**CAMECO RESOURCES
CROW BUTTE OPERATION**

Additional Information on Niobrara River Fault

RAI #9 NIOBRARA RIVER FAULT STUDY

Figure 1

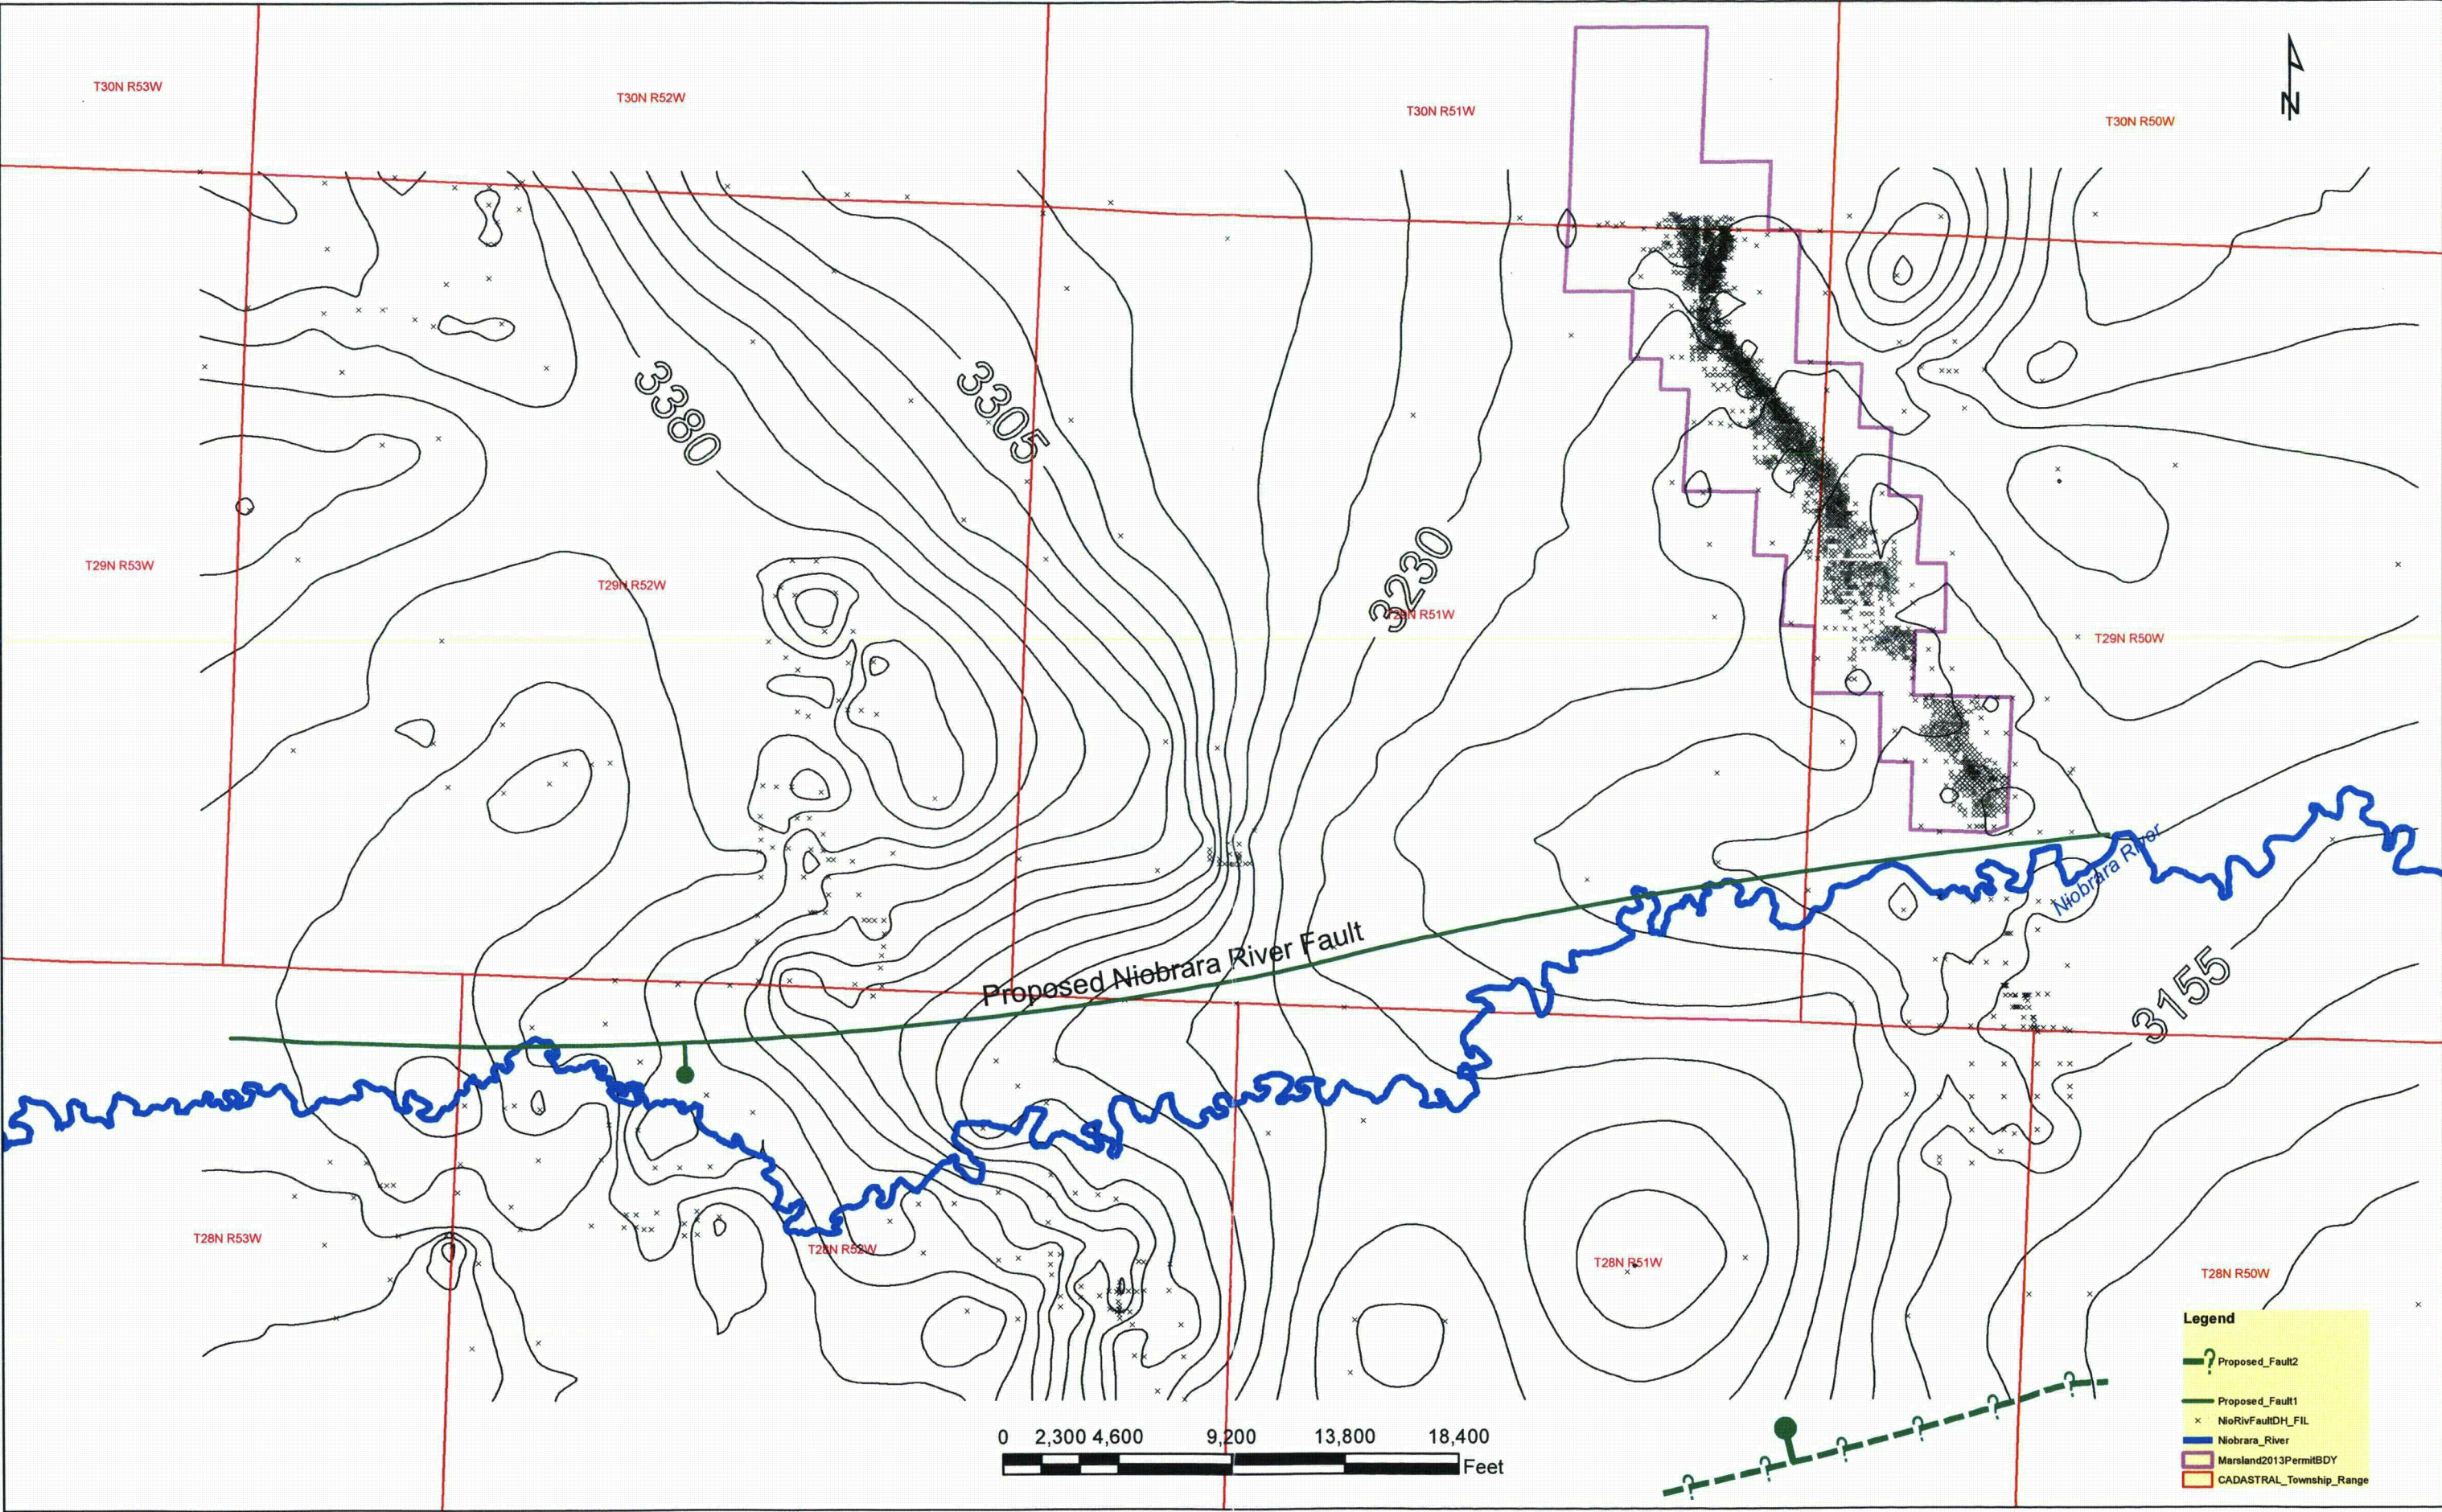
On March 27, 2014, during a conference call between Project Managers for the NRC and CBR, NRC Marsland Project Manager, Tom Lancaster, indicated that efforts to locate additional information about the Niobrara River Fault by NRC staff had been unproductive. In light of the limited information available, Mr. Lancaster requested that CBR make the following revisions to Figure 2.6-14 to assist with NRC assessment of the fault; (1) use contour lines in place of colored contours; (2) Reduce the relative size of the borehole locations shown on the figure; (3) Extend the map further to the east of the MEA if data exists for that area; (4) Correct and/or describe any "bull's-eyes" that may be present in the data; (5) plot on larger paper such as 11'x17', and (6) on a new figure, present a close up of similar information for the southern portion of the Area Of Review (AOR).

Attached with this response is Figure 1 that incorporates the suggested revisions to the Regional Pierre Surface map that will be included in a revised Figure 2.6-14. Figure 1 is marked as a DRAFT at this time and is presented to determine if it meets NRC approval. Likewise, Figure 2 shows similar information for only the southern portion of the AOR and is included to provide greater detail in the vicinity of the MEA.

Both figures depict the Pierre Formation surface topography, Cameco drill hole locations, MEA permit boundary, location of the Niobrara River, and the proposed Niobrara River Fault location as depicted by DeGraw(1971). All drill holes depicted have been completed by Cameco Resources or its predecessors and the depths to the Pierre surface determined from geophysical logs. The regional map utilizes a 15 foot contour interval, and the smaller-scale Southern Area Of Review map uses a 5 foot contour interval. Neither map shows the closely stacked east-west

trending contour intervals that would be expected along the proposed Niobrara River Fault had the Pierre Formation surface been offset due to faulting along the proposed fault.
